Salem Generating Station Unit 1  
Renewed Facility Operating License No. DPR-70  
NRC Docket No. 50-272

Subject: Submittal of Relief Request Associated with the Third Ten-Year Inservice Inspection (ISI) Interval

REQUEST FOR ADDITIONAL INFORMATION REGARDING  
SALEM GENERATING STATION, UNIT 1  
REQUEST FOR RELIEF S1-I3R-114  
DOCKET NUMBERS: 50-272 (TAC NO. ME8565)

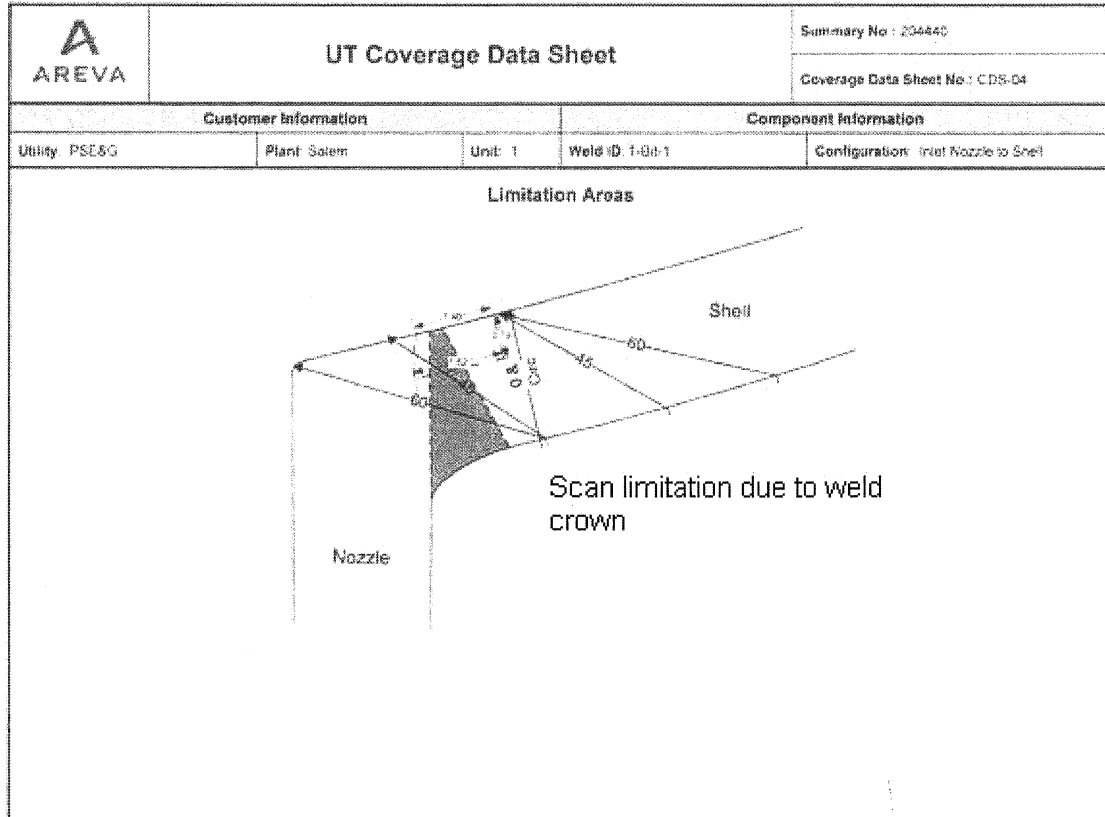
RAI 5: The licensee has provided only general information regarding impracticality of obtaining ASME Code-required volumetric examinations for Boric Acid Injection Tank inlet and outlet nozzle-to-head Welds 1-BIT-1 and 1-BIT-2. Statements such as "nozzle configuration and surface conditions" are inadequate to describe the bases for not obtaining the ASME Code-required examination volumes.

Please submit detailed and specific information on any outside diameter surface feature, such as weld crown, diametrical weld shrinkage, or surface roughness conditions that caused limited volumetric coverage during the subject piping weld examinations. Discuss the efforts that were used to correct these conditions.

Scanning can not be performed from the nozzle side of Weld 1- BIT-1 and 1-BIT-2 due to the nozzle weld configuration. Weld crown reduction on the vessel side of the weld could not be performed to improve contact as it would compromise the original outer radius or the tapered fillet portion of the weld. Examination coverage is limited by the joint configuration only. No limitations have been attributed to scanning surface condition. The illustration below depicts weld 1-BIT-1 and is also applicable to 1-BIT-2.
